CITY OF PORTLAND, MAINE

subject: alterations in the restaurant building  
on Island Avenue, Peaks Island opposite the end  
of Brackett Avenue (formerly Carlson's)

Subject: Building permit for providing concrete  
surface over existing wood floor in kitchen  
and toilet room of the restaurant on Island Ave.,  
Peaks Island opposite the end of Prescott Ave.  
(formerly Carls. St.)

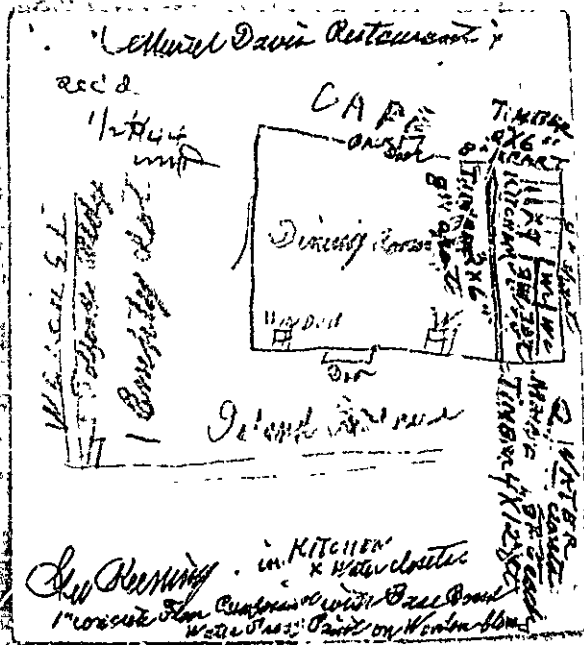
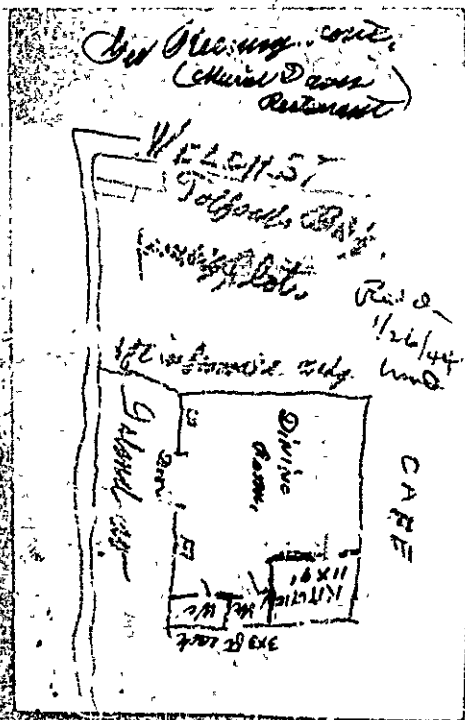
1. While the Building Code does not stipulate any particular thickness for such a concrete surfacing, it is my belief that a 1-inch thickness is not sufficient to give reasonable assurance of a permanent sound floor surface such as I believe the Health Department requires. The sketch says: "1-inch concrete floor reinforced with Eagle Brand Water Proof Paint on wooden floor." It is not clear that you are using any reinforcing mesh in the concrete surface. Such reinforcing is usually considered essential for a serviceable job, but the 1-inch thickness is hardly enough to use such a reinforcing mesh in. I cannot find any indication of what you propose to do where the new surfacing meets the walls or partitions at the baseboard around both the kitchen and both toilet rooms. Neither do you show whether the vestibules as well as the toilet rooms are to be so surfaced. It is my belief that the Health Department are after a permanent sanitary job, and the only way that I know of that it can be produced is to put in the floor of sufficient thickness and adequately reinforced so that it will not crack up and to provide against all walls and partitions a sanitary base or base which tends to keep water used in washing, the floor and other moisture from entering the crack between the floor surface and the walls or partitions. It seems obvious that if after a while cracks develop in the floors or undue moisture gets beneath the concrete surface and around the edges, the Health Department will require the job to be done over at the purpose for which it is obviously intended would not have been met.

2. Our original plans of the restaurant when the building was built show a vestibule in front of each toilet room. Your sketch shows only the outline of toilet room without any indication of vestibules. The original plan shows each toilet room three feet by six feet and each vestibule three feet by four feet six inches. Your sketch shows "2 water closets 2x3 each". These questions are quite vital for those who are paying the money for doing this work and I respectfully recommend that you get all of these details straightened out with the Health Department before you actually start any work under this permit.

3. As regards the strength of the floor your sketch shows 2x6 joists under this kitchen eight inches apart which would be 10 inches from center to center. The original plan shows 2x6's, 12 inches from center to center on about a 10-foot span. If your figures are right as to the spacing and the span is 10 feet the strength is sufficient for the addition of 1-inch of concrete, but if you finally decide to put in more it is likely that the joists would require strengthening. I do not know how much there is by way of weight on this kitchen floor such as a heavy range, etc., or where with relation to the spans of the 2x6's these weights may be located, but even if the joists are spaced as you say the extra weight of even 1-inch of concrete is likely to deflect the joists or make them sag so that the concrete surfacing will crack up. If the floor joists are as shown on the original plan here, then the joists must be reinforced regardless of how much concrete is put on.

4. The main beam nearest the kitchen is indicated on the original plan as 6x12 on a 10 foot span; but your sketch indicates the main beam as 4x12. If your sketch is right then necessary reinforcing must be done of the main girder also. In the light of this paragraph and the one next above it is necessary that you straighten out this information in this office, and if strengthening is necessary indicate in a clearer sketch just how you propose to do it, before any concrete is placed on the floor.

6. On the original plan of the restaurant the entrance door on Island Avenue is shown as the only means of getting in or out of the restaurant. If that is true it may be found necessary to require an emergency exit. This restaurant was built under the Building Code of 1928 which has since been superseded by the Building Code of 1941. We are not permitted to apply the Building Code of 1941 to this building as regards exits; but since the disaster of Coconut Grove more care has been shown with regard to all safety features in connection with places such as this restaurant where the Municipal Officers have to approve a license of one kind or another before the place can be legally used. I am not just sure what will be the outcome of this question; but now that the restaurant is being opened again it seems best to inform the owner of the problem.

grad. Evhion Restaurant, Pearl's Island

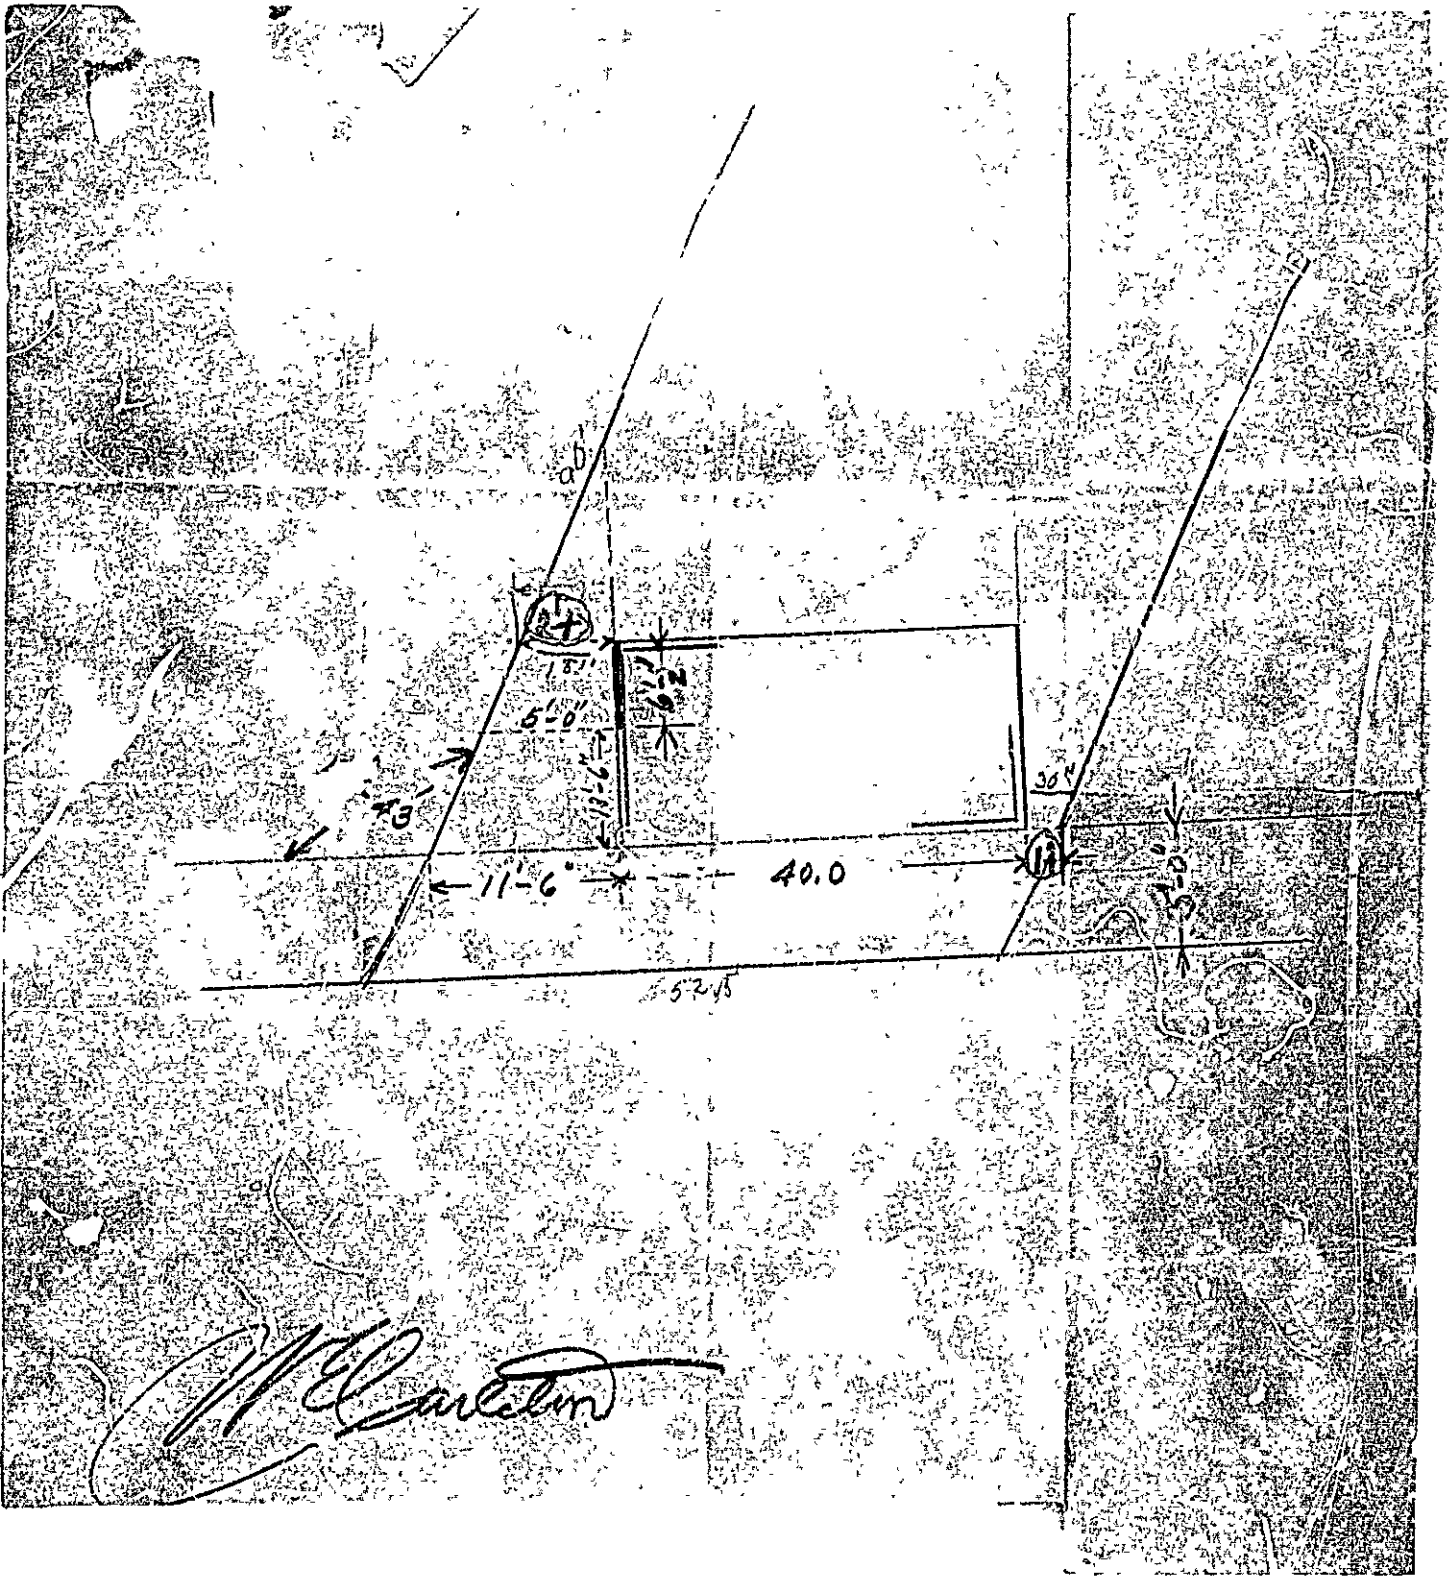
X  $2 \times 12 - 20'$  span -  $14''$  O.C. Approx. F. good for  $1760^{\#}$   
 $20 \times 1.17 \times 105 = 2457^{\#}$

X  $2 \times 8$  on  $13'$  span -  $15''$  O.C. good for  $1202^{\#}$   
 $13 \times 1.21 \times 105 = 1706^{\#}$

In  $14'$  length figure 2 spans go to  $9'$  span  
 $2 \times 6 - 12''$  O.C. and 2 spans  $11'$  span each -  $2 \times 8 =$   
 $14''$  O.C.

(17)  $2 \times 6 - 12''$  O.C. on  $9'$  span good for  $976^{\#}$   
 $9 \times 1.0 \times 105 = 945^{\#}$

(18)  $2 \times 8 - 14''$  O.C. on  $11'$  span - good for  $1422^{\#}$   
 $11 \times 1.17 \times 105 = 1351^{\#}$

$10 \times 11 \times 105 = 11550$  -  $7\frac{1}{2} \times 12$  good for  $15,000^{\#}$   
 $10 \times 9 \times 105 = 9450$
